Re: Turkey Point Units 3 and 4
Docket Nos. 50-250 and 50-251
Response to NRC Request for Additional Information Regarding
Extended Power Uprate License Amendment Request No. 205

Turkey Point Units 3 and 4
RESPONSE TO NRC SRXB REACTOR SYSTEMS RAI
REGARDING EPU LAR NO. 205

Response to Request for Additional Information

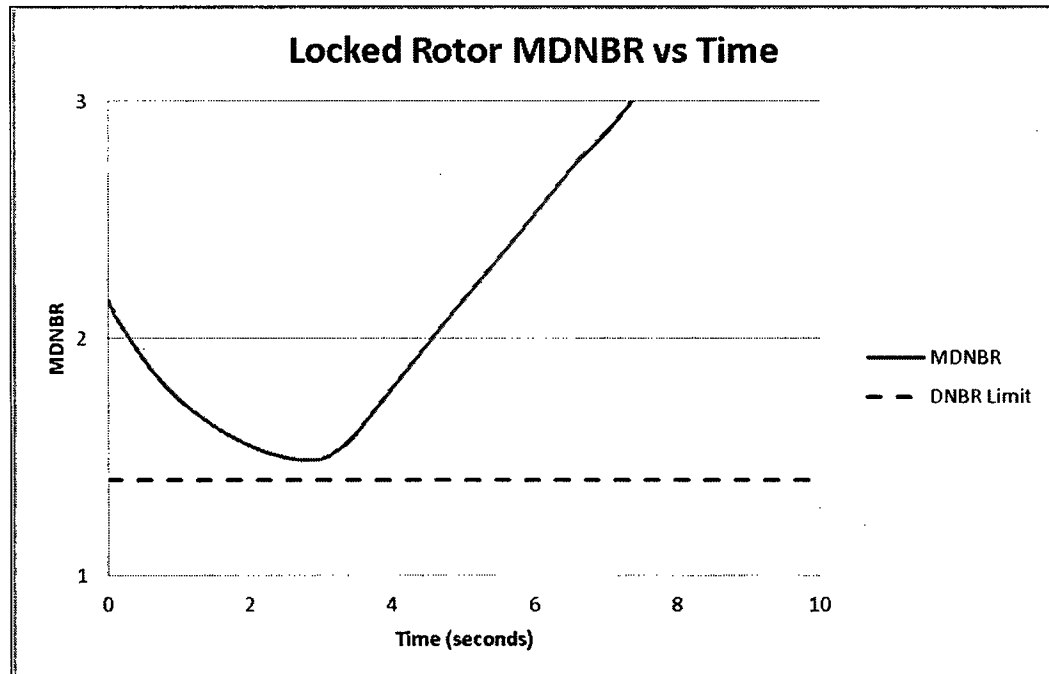
SRXB-3.5 For Licensing Report Section 2.8.5.3.2, Reactor Coolant Pump Rotor Seizure and Reactor Coolant Pump Shaft Break, provide a plot of departure from nucleate boiling ratio versus time.

Below is a plot of the Minimum Departure from Nucleate Boiling Ratio (MDNBR) versus Time for the Reactor Coolant Pump Rotor Seizure and Reactor Coolant Pump Shaft Break (referred to as Locked Rotor) for the Turkey Point Extended Power Uprate. The plot below represents the results for the Upgrade fuel, which bound the results of the Debris-Resistant Fuel Assembly (DRFA) fuel. The applicable DNBR limit is also shown on the plot.
